ALERT SERVICE BULLETIN NO. ASB315-64

G 103 TWIN ASTIR	All
G103 TWIN ASTIR TRAINER	All

Limitations of Operation

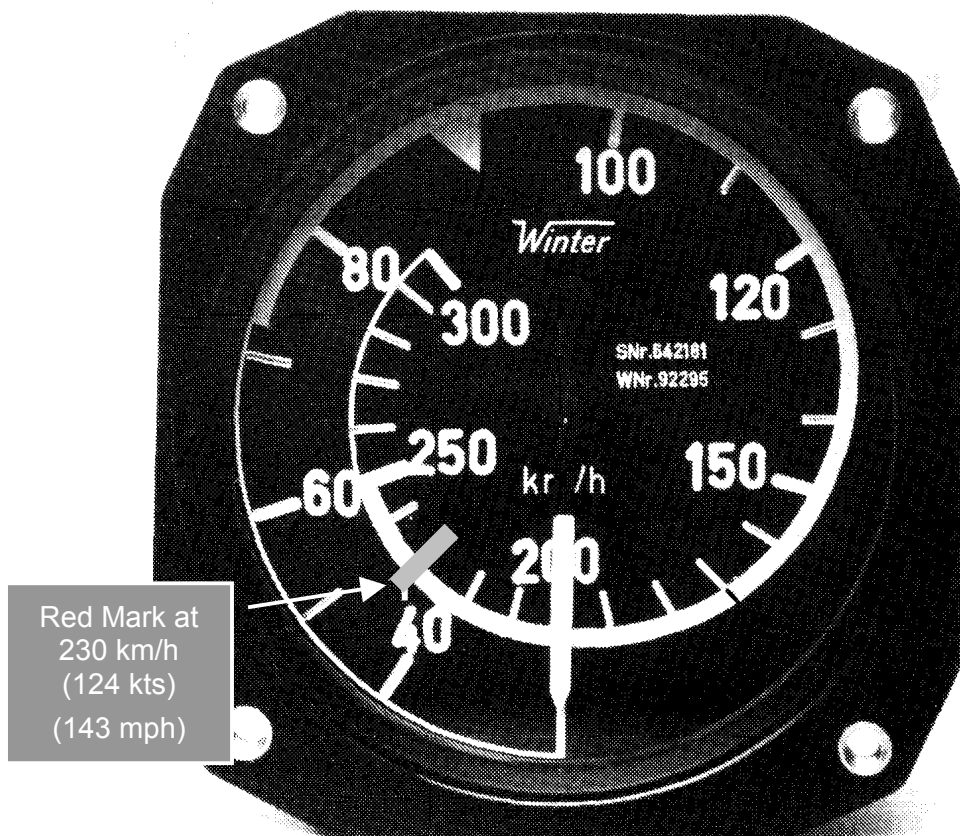
The maximum speed in rough air is reduced to $v_B = 170$ km/h (92 kts / 105 mph). The maximum speed in calm air and as a consequence of that the maximum speed with airbrakes extended are reduced to $v_{NE} = v_{DF} = 230$ km/h (124 kts / 143 mph). The following must be performed for that:

1. Apply a red mark to the front and the rear airspeed indicator at **230 km/h (124 kts / 143 mph)**:
